RCWD BOARD OF MANAGERS WORKSHOP

Technical Responses to the Board of Water and Soil Resources Comments on the Houle Wetland Bank Part A Application

January 27, 2011

Public Water Wetland

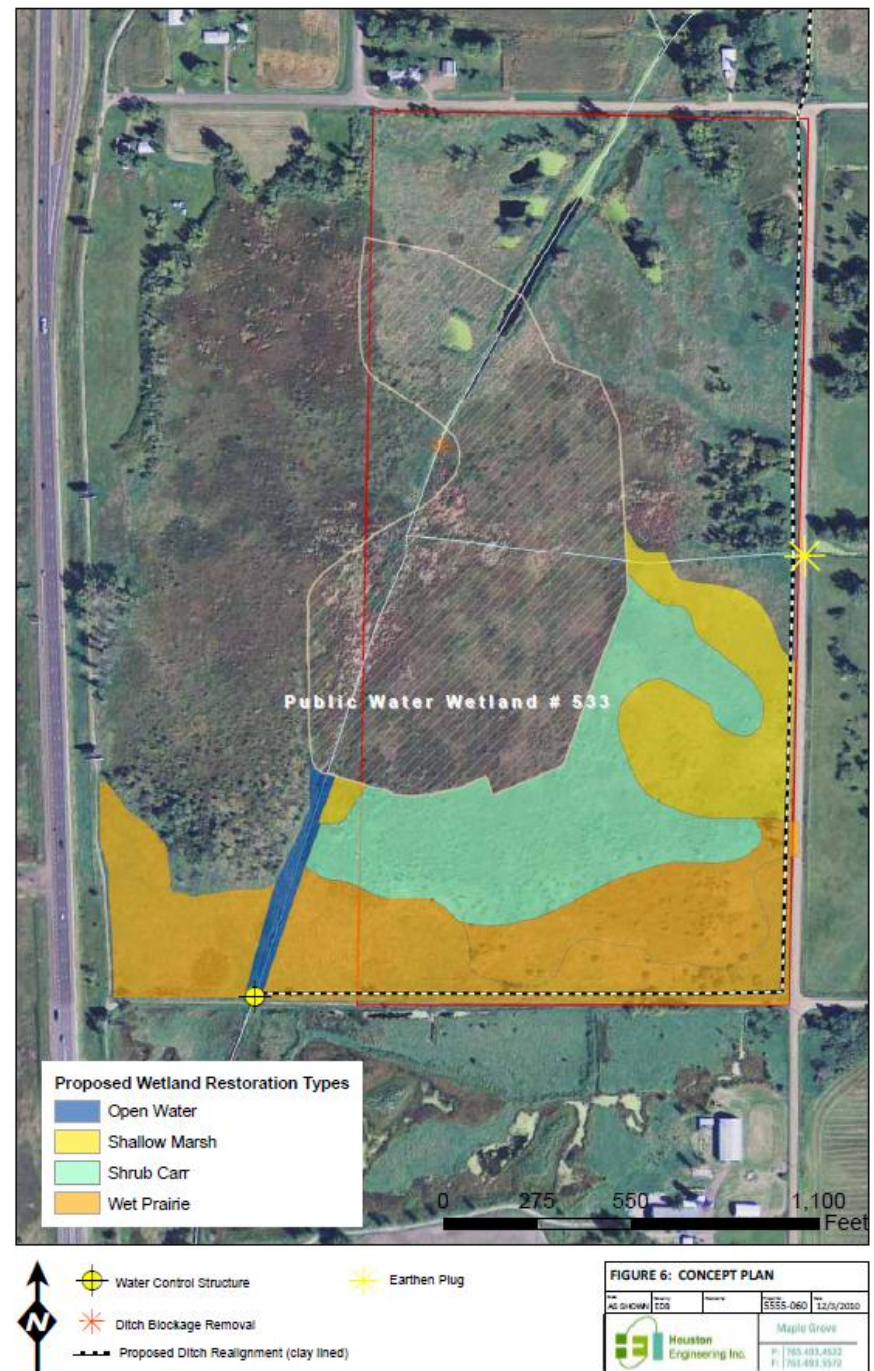
Comment No.	BWSR Agency Comments (Lynda Peterson Email dated 12/22/2010)	Response
BWSR-1	First and foremost the DNR Division of Waters and Rice Creek WD need to come to a conclusion on whether areas within the project are DNR Protected Wetlands. If this is resolved then RCWD may want to continue with this project.	We understand there is an interpretation from BWSR staff, supported by the Attorney General, which does not allow credit for the restoration of wetlands located within the boundary of a public water (PW) or public water wetland (PWW). Our understanding of the rationale for this is that PW's and PWW's because of their regulation by DNR, are not considered wetlands eligible for credit. According to the DNR, reclassifying the Public Water Wetland is a possibility, but an uncommon occurrence. Should the original classification as a PWW be in error, this may be one reason for re-classifying the Public Water. The RCWD would have to formally request that the DNR proceed with reclassification. Attachment 1 shows the PWW boundary relative to the boundary of the former Houle WMA. The area of the PWW is 24 acres. The portion of the project area downstream of the current sediment blockage is believed to be partially drained. There are 34.2 acres of degraded wetland below (i.e., downstream from) and 23.2 acres above (i.e., upstream from) the current blockage. The PWW classification seems tenuous and RCWD will be requesting assistance from the DNR to re-evaluate their 1979 determination. Attachment 1 shows no open water on those aerial images nearest in time to the 1979 determination date. None of the wetlands shown on the National Wetland Inventory were types 3, 4 or 5. This provides some evidence of the need to revisit the PWW determination.

- PWW area is 24 acres
- Ditch blockage is accumulated sediment and subject to washout
- At a minimum, wetlands downstream of blockage are partially drained
- Area with restored hydrology (colored) outside of the PWW boundary is ~ 5 acres

Attachment 2

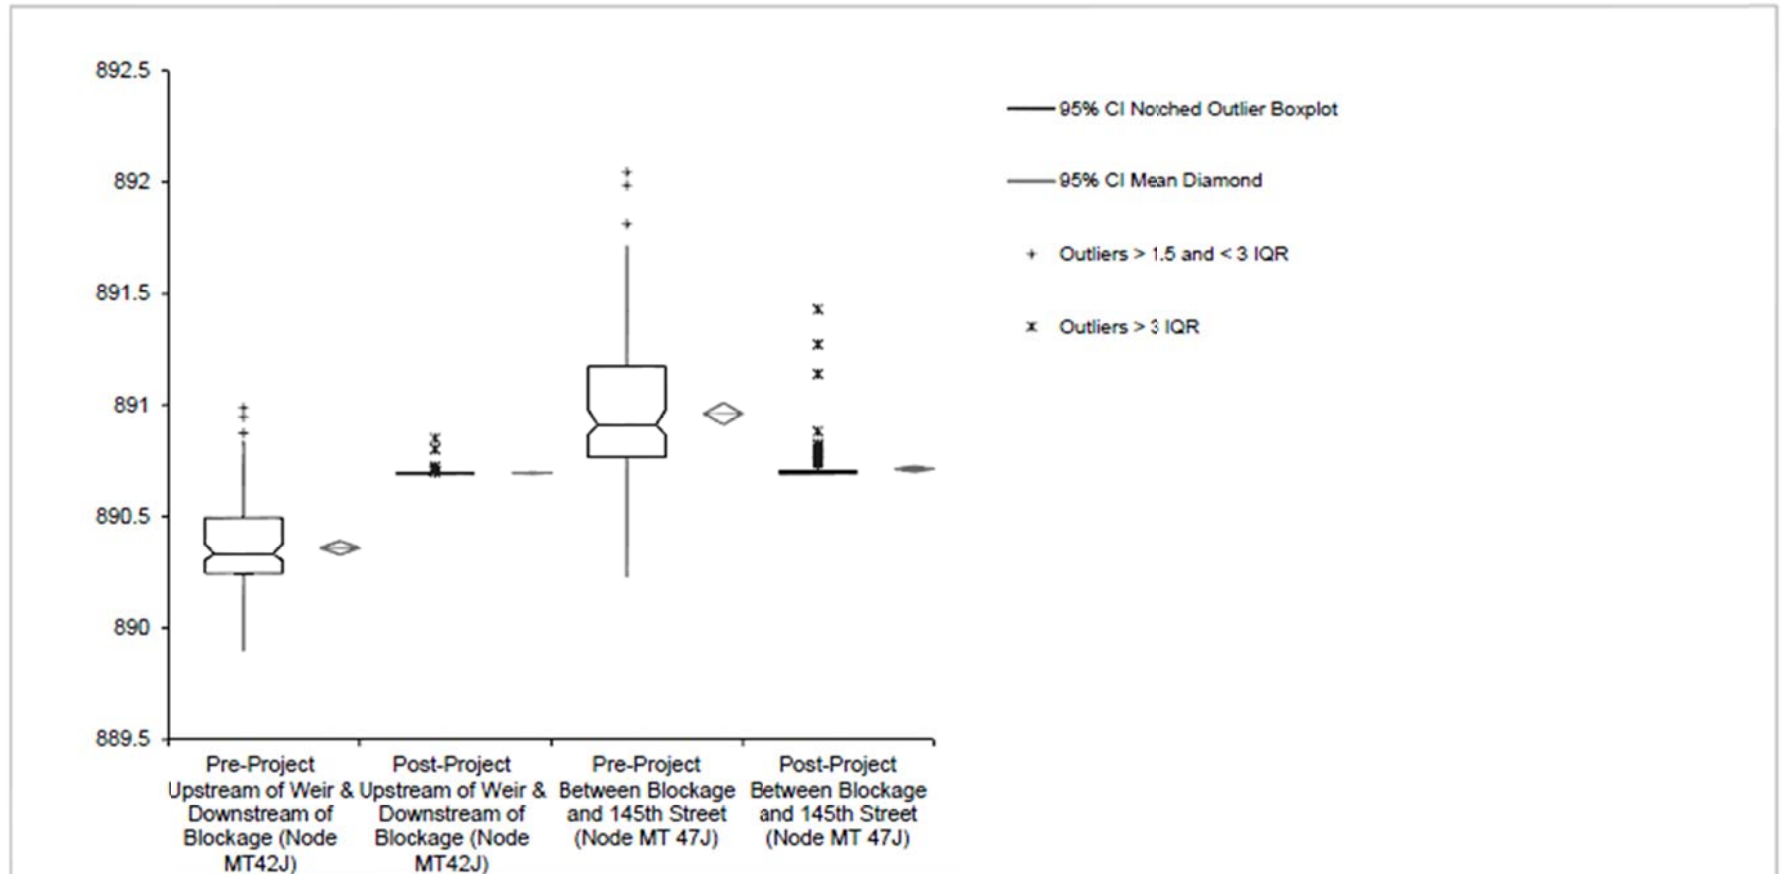
BWSR - 4	Elevations of culverts upstream will need to be submitted for review.	The elevation of the culvert at 145 th Street is 889.11, and the Main Trunk Tile upstream from this culvert is 891.77. Please note that extensive hydraulic analysis has been completed of the existing and proposed structures and tile systems for both the current and future land uses. These analyses are included in the repair report and addendum to the repair report, which can be found in drainage system page on the District's (website http://ricecreek.org/index.asp?Type=B_BASIC&SEC={FFBA6E9B-055A-4DE2-A1AC-2601F98AF31B}). Additional relevant culvert elevations can be included in the Part B Wetland Banking Plan. However, extensive hydrologic and hydraulic analysis of the public drainage system has been completed, sufficient for final design purposes.

Test	Describe - Comparative		
Performed by	Pre-Project Upstream of Weir & Downstream of Blockage (Node MT42J), Post-Project Upstream of Weir & Downstream of Blockage (Node MT42J), Pre-Project Between Blockage and 145th Street (Node MT 47J), Post-Project Between Blockage and 145th Street (Node MT 47J)		Date
	Mark Deutschman		11 January 2011

FIGURE 6: CONCEPT PLAN				
Scale:	Drawn by:	Checked by:	Project No.:	Date:
AS SHOWN	EDB		5555-060	12/3/2010
 Houston Engineering Inc.			Maple Grove	
			P: 763.493.4522 F: 763.493.5572

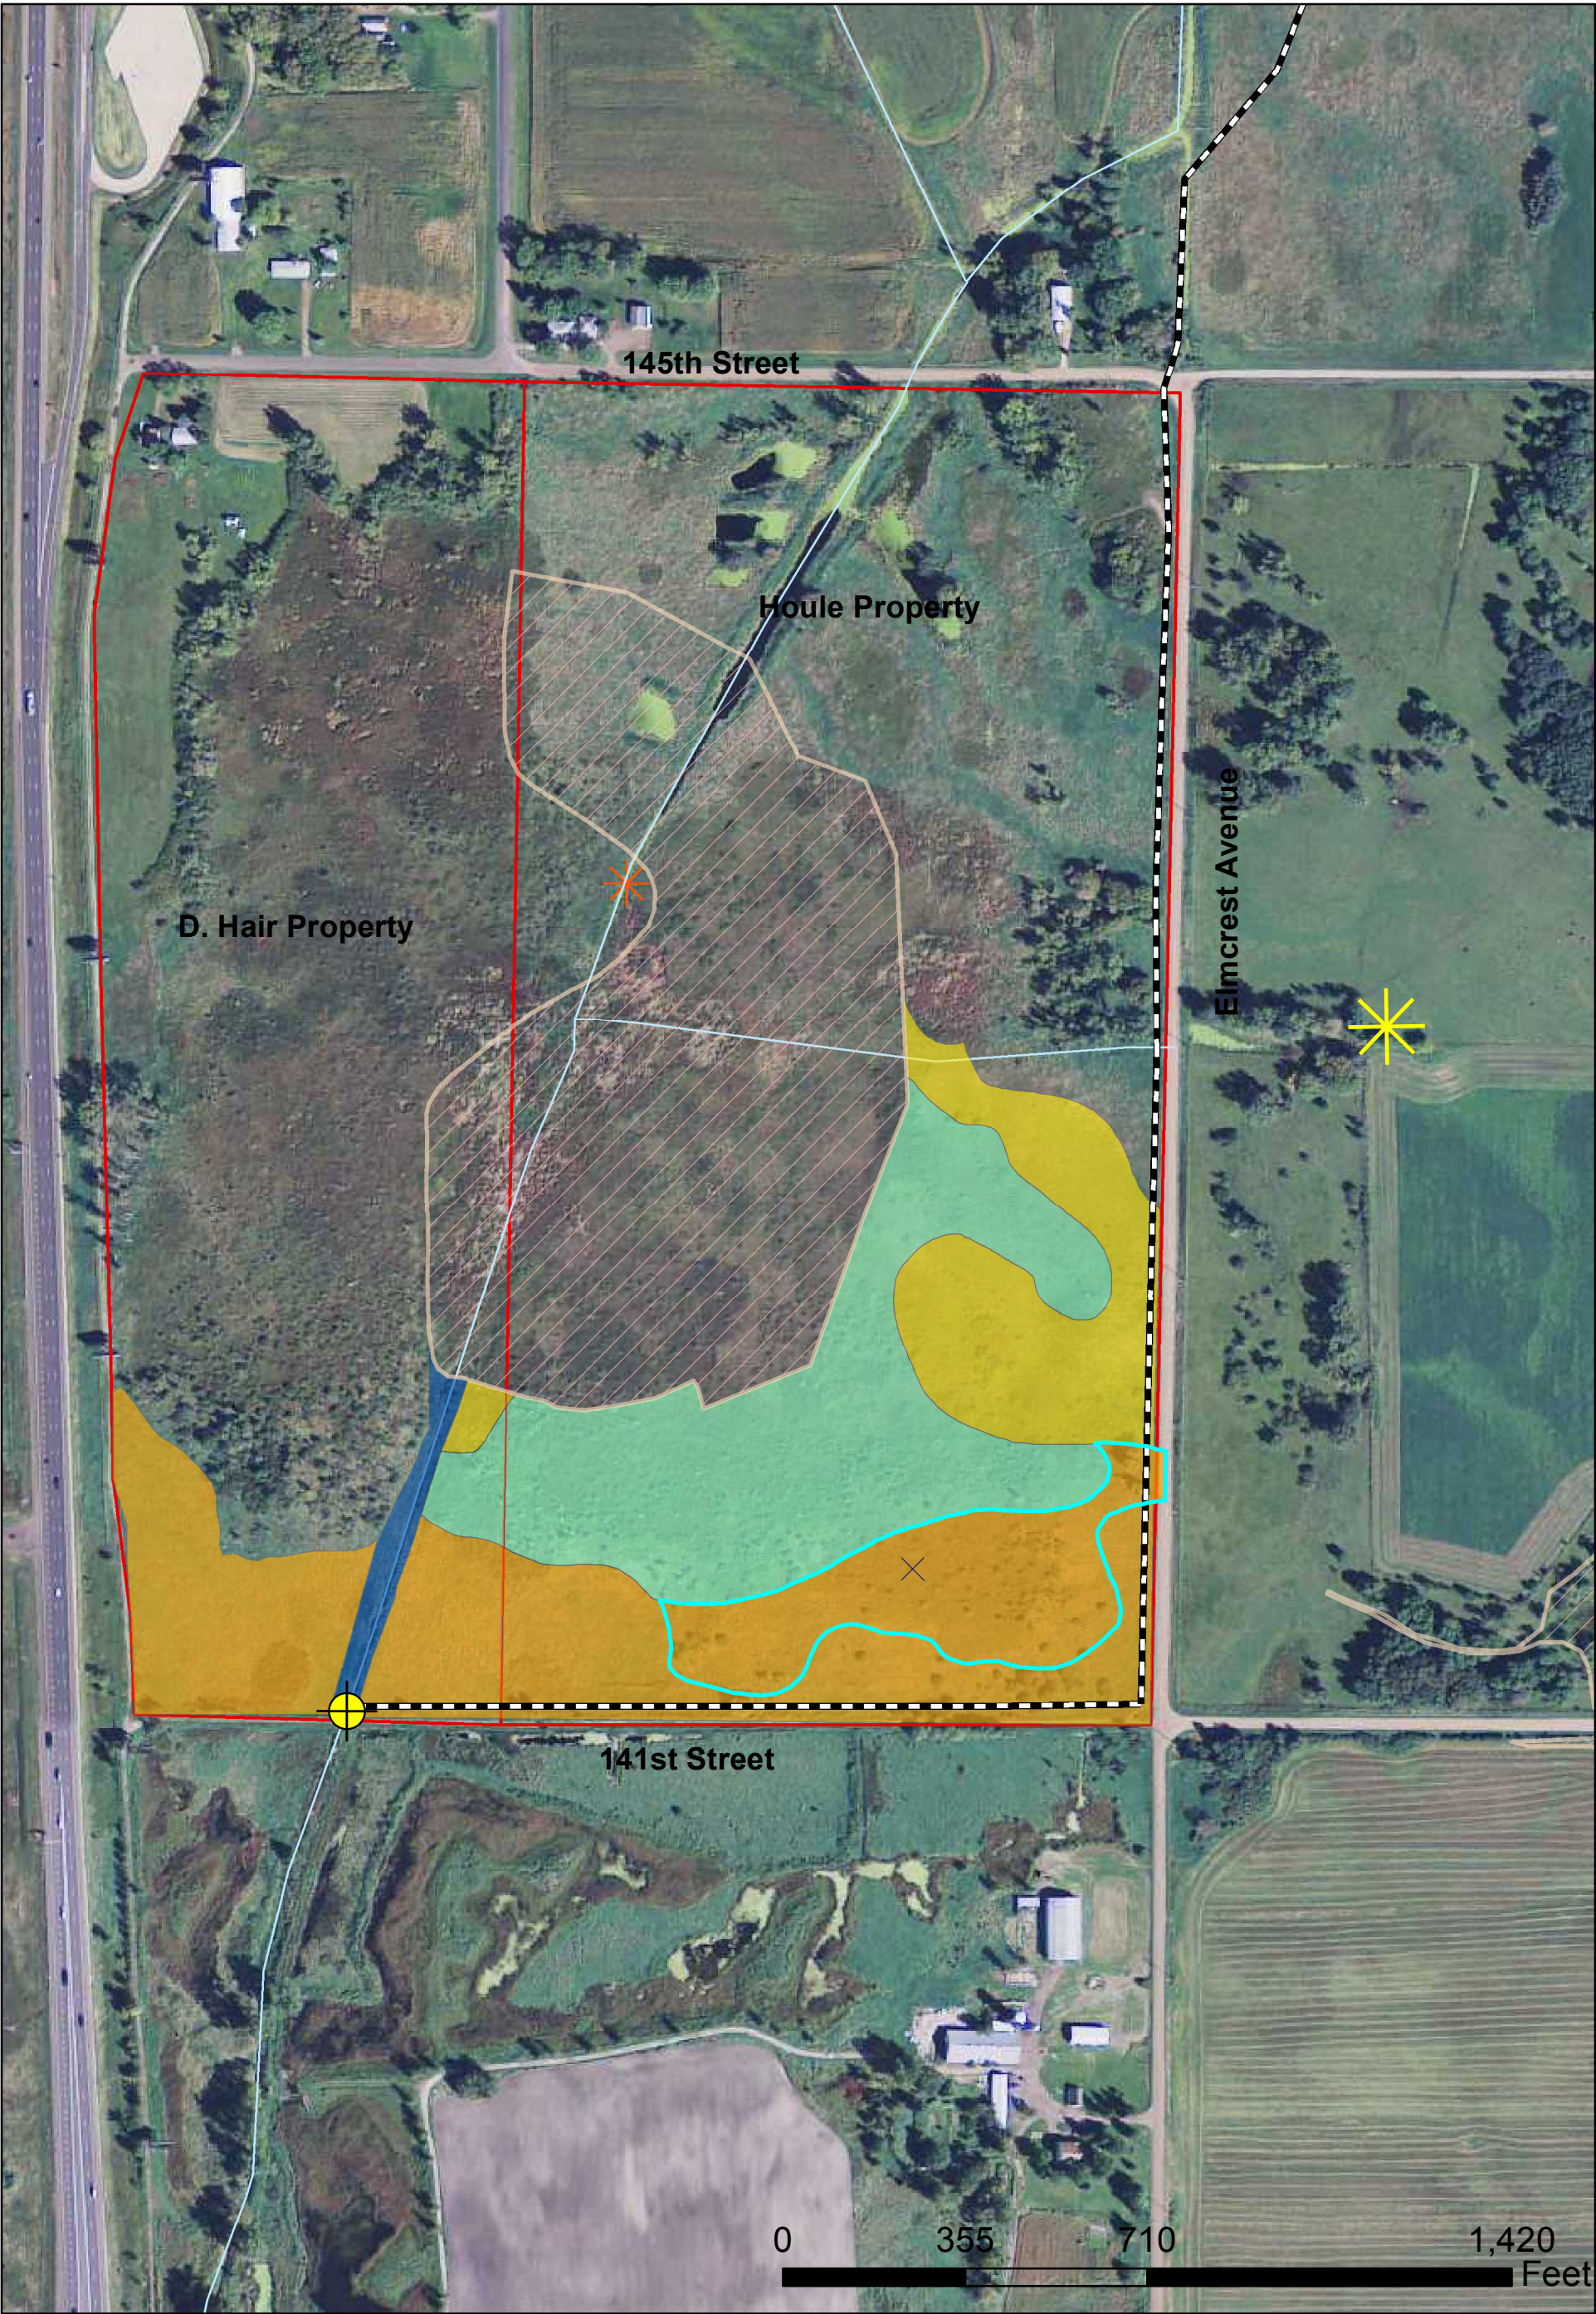
BWSR - 2	The Anoka County Highway Department needs to approve moving JD4 along their county road on the east side of the project. They may not want a ditch there for safety reasons.	Elm Crest Ave N is a city street located on the boundary between the City of Columbus and Forest Lake and so dually owned by the communities. The re-aligned open channel will not be within the road right of way. Both communities have been involved in developing the restoration project concept and the location and design of the realigned open channel has not been an issue. The communities will continue to be consulted as the project proceeds. Expectations are that design of the re-aligned channel will be completed in a context-sensitive manner, which enhances the restoration of the project area. The open channel is expected to be located beyond the roadway recovery zone.

BWSR - 3	If JD4 is to be moved along the road, more information on the design and cross section of the proposed clay liner needs to be submitted. The entire ditch may need to be lined to protect any lateral effect from the ditch. Calculations of scope and effect will need to be reviewed by BWSR technical staff to ensure that minimal drainage will occur.	The current design concept and Opinion of Probable Construction Cost (as presented in the Addendum to the Repair Report) assumes the entire bottom and western side slope of the new JD-4 branch will be lined with clay, along the entire length of the branch that extends through the Houle Wetland Bank Site, to an extent that will prevent inadvertent drainage effects on the adjacent wetlands. Detailed cross-sections and design information will be submitted as part of the Part B application. A technical specification for permeability will be included in the construction documents.

BWSR – 8	It is suggested to remove the spoil piles within the corridor of the existing ditch. This may help in vegetative control of invasives.	Yes, this will be included as part of the overall restoration plan as was noted in the Part A Application.
BWSR - 9	There is concern over the need for an easement on the Hair property. Will it be a flowage easement or part of the wetland bank application for credit? If credit is proposed for this area, then Mr. Hair will need to be a co-applicant on this plan. Mr. Hair's property will need to be part of the application for banking with vegetation management and what type of restoration credit will occur. It is not clear in Part A as to what the intent of this property will be.	The Part A application and the project will include the property owned by Mr. Dan Hair. After formal discussions have been finalized with Mr. Hair, he will be added as a co-applicant on this plan. As initial discussions with Mr. Hair have been positive, it is intended at this time that a portion of Mr. Hair's property will be restored and included in the Wetland Bank, should the site characteristics allow for this. Mr. Hair's property is now included in the conceptual plan, in Attachment 3. The intent is to restore the wetland through restoration of the natural hydrology regime and native vegetation to degraded wetland. The proposed weir would restore hydrology consistent with the surrounding ground elevation. There are 34.2 acres of degraded wetland downstream of the blockage shown on Attachment 3. Of these 34.2 acres, 12.3 acres are considered severely degraded and 21.9 acres are considered moderately degraded based on the current functions and services information. The credit is available in demonstrating a quality shift in the pre and post function and services evaluation (MnRAM); specifically in hydrology (outlet condition) and vegetation.

Ditch Blockage Removal

Proposed Ditch Realignment (clay lined)
